SUBJECT: Forwards suppl response to GL 95-07, "Pressure Locking & Thermal Binding of SR Power-Operated Gate Valves."
Partial calculation rept encl.

Subject: Oconee Nuclear Station
Docket Nos. 50-269, 50-270, 50-287
Supplemental Response to Generic Letter 95-07:
Pressure Locking and Thermal Binding of Safety-
Related Power-Operated Gate Valves

Response to NRC questions related
to Generic Letter 95-07

FIGURE 2

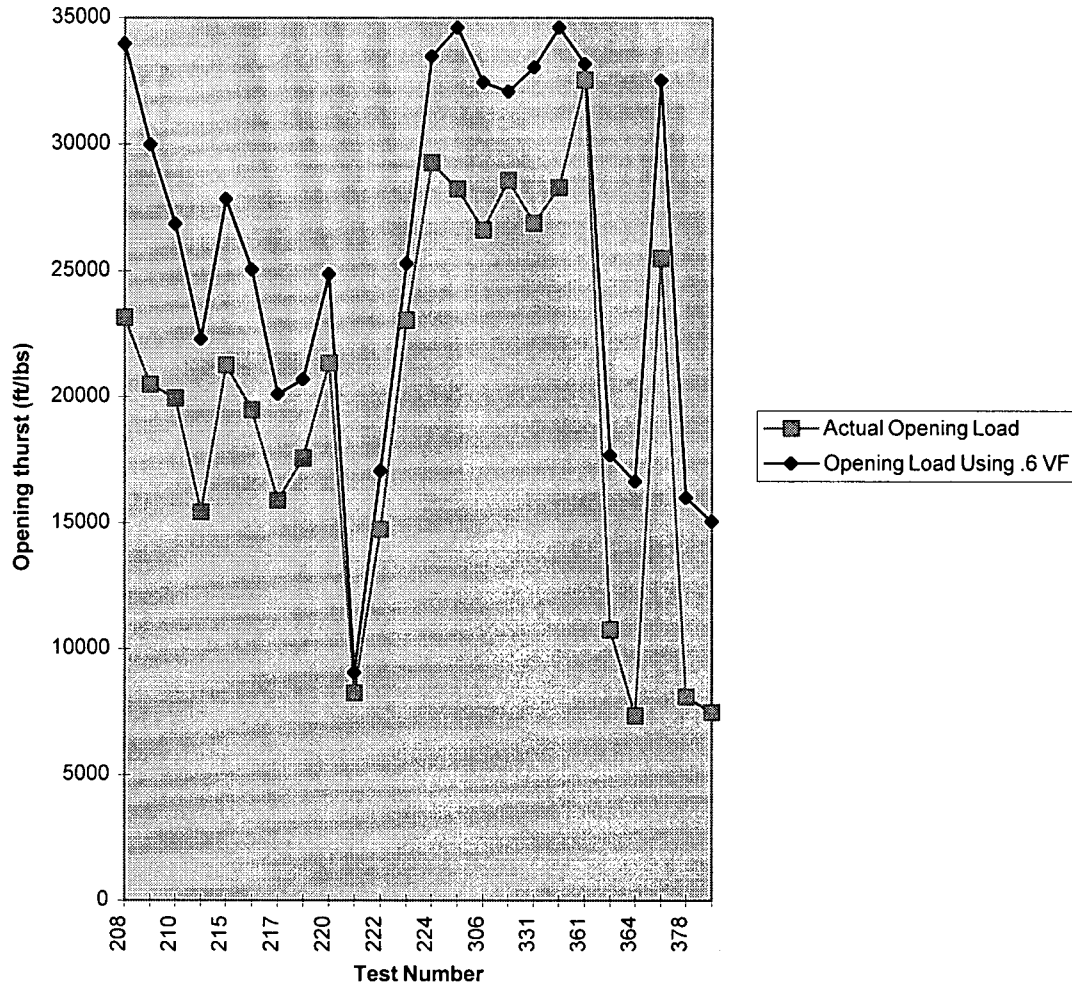
The February 13 submittal stated that calculations were used to demonstrate that valves 1, 2, 3 HP-428 (reactor coolant return from letdown valves) are capable of opening under pressure locking conditions. A double disk gate valve pressure locking prediction methodology was used to calculate the thrust required to open the valves during pressure locking conditions. Provide the test procedure/results that validated this pressure locking prediction methodology and the information necessary to evaluate if valves 1, 2, 3 HP-428 are similar to the rest of the valves. Recent pressure locking testing sponsored by the NRC and performed by INEEL indicated that thrust requirements exceeded double disk pressure locking prediction calculation results. The results of this testing have been placed in the NRC's Public Document Room. Discuss if these INEEL pressure locking test results can be used to validate your double disk gate valve pressure locking prediction methodology. Provide 1, 2, 3 HP-428 pressure locking, actuator capability, and thermal induced pressure calculations for our review.

However, Duke was interested in using the INEEL test results to review our original methodology. Although the results from INEEL are preliminary in that they lack final conclusions and detailed test descriptions, Duke has used the INEEL Anchor Darling preliminary test results dated January 23, 1997, as a check to ensure our methodology is sound.

When using a 0.6 Valve Factor and neglecting stem rejection loads, our dual seat DP load methodology bounds all of the preliminary test data for the 6-inch Anchor Darling double disc gate valve tested by INEEL.

See Figure 1 for the calculation data and Figure 2 for the comparative graph.
